FortisBC Inc.
2017 Cost of Service Analysis and Rate Design Application

INFORMATION REQUEST NO. 1 TO ICG

A. WILL CLEVELAND TESTIMONY

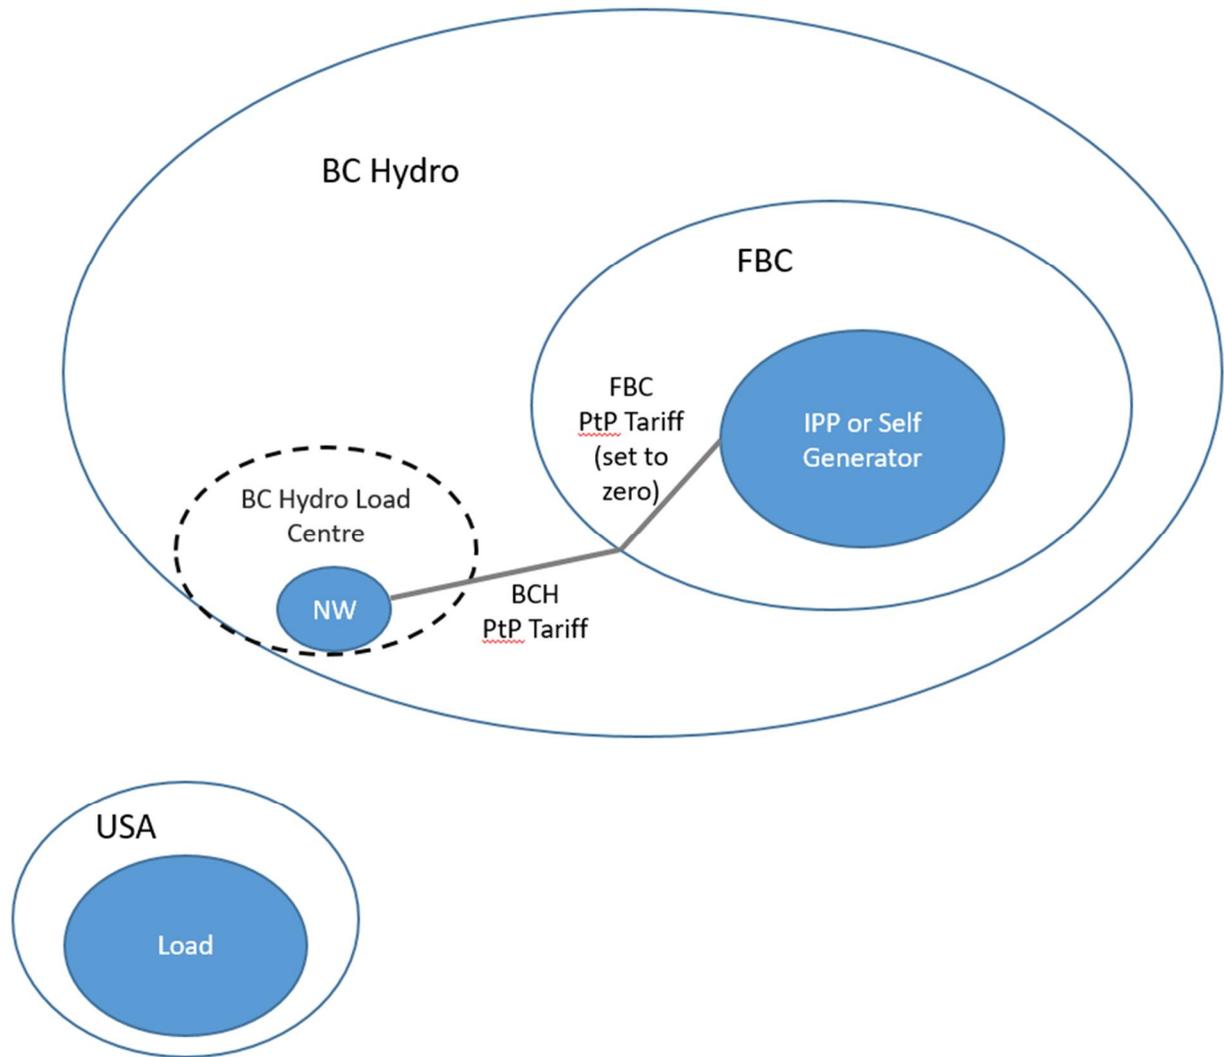
In the context of British Columbia, I believe the following additional example is illustrative. Scenario C: Export from Embedded Generator to New Westminster depicts a generator within FBC's service territory exporting energy to the New Westminster electric utility¹⁸. Under order G-12-99, this transaction would attract the zero rate for the use of the FBC transmission system, and the typical rate (as defined in the response to BCUC ICG IR 1.6.1) for the use of the BC Hydro transmission system. This aligns with the description of the license plate approach provided in the quoted FERC opinion: New Westminster pays for the cost of the transmission system within its "zone" (BC Hydro's transmission system). Having made this contribution towards the embedded cost of the BC Hydro transmission system, New Westminster gets access at no additional cost to the transmission system of FBC – the other transmission system included within the harmonization area. My interpretation is that FBC's proposed changes in the current application would not impact this scenario.

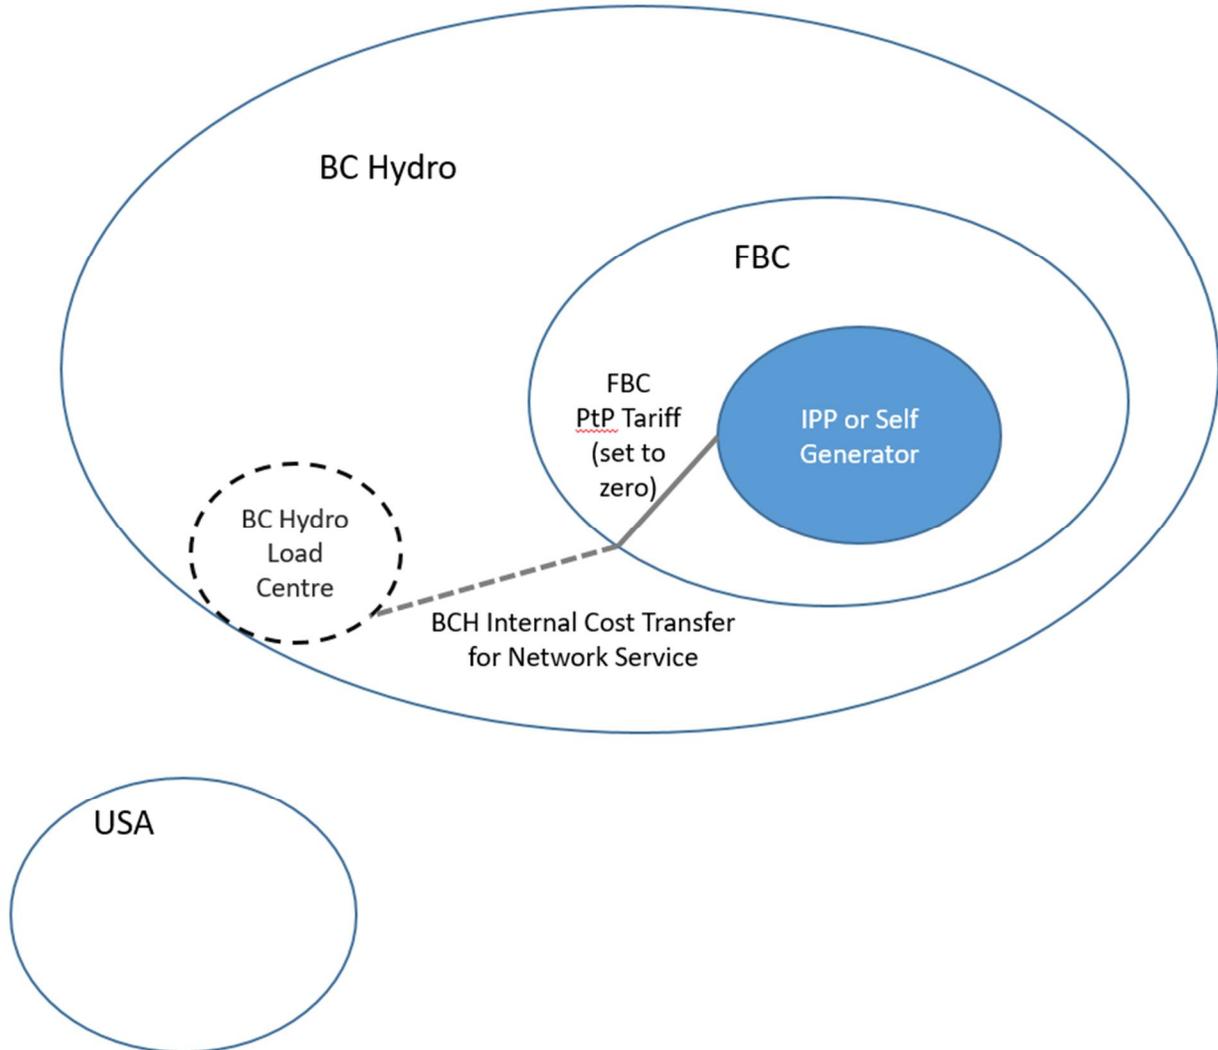
Compare this with Scenario B (Current Treatment): Export from Embedded Generator to BC Hydro. This scenario was provided in my original prepared testimony¹⁹ and is provided here to facilitate comparison. In this scenario, a generator within FBC’s service area is selling power to BC Hydro for BC Hydro’s use to serve native load. Under the current treatment, this transaction results in the zero charge for the use of FBC’s transmission system. In my view this is consistent with the license plate approach. BC Hydro’s customers are paying for the BC Hydro transmission system through their retail rates. This is their payment under the license plate approach, and it gets those customers access to the other transmission system included within the harmonization area (FBC’s transmission system) at no additional cost.

Under FBC’s proposed changes, this transaction would not receive the zero rate for the use of FBC’s transmission system. If BC Hydro accessed that generation resource located in the FBC service area on behalf of its customers (i.e. procured energy to serve native load), BC Hydro’s customers would have to pay the cost of BC Hydro’s transmission system (since these costs are already included within BC Hydro’s rates)²⁰, as well as FBC’s typical point-to-point transmission
